Appl. No. 10/795,930 Reply to Office Action dated May 8, 2006

Amendments to the Drawings begin on page 11 of this paper and include both an attached replacement sheet of FIG. 2 and an annotated sheet of FIG. 2 showing changes.

FIG. 2

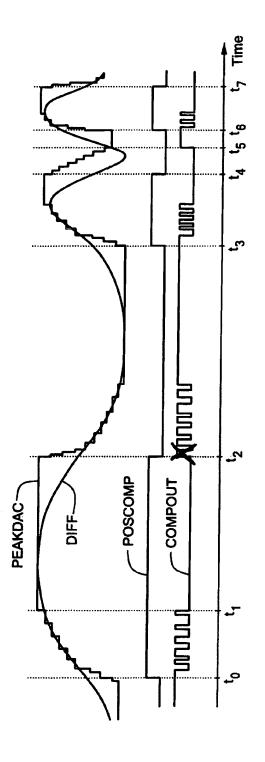
In the drawings, Applicants have amended FIG. 2 above, merely to correct a small timing error.
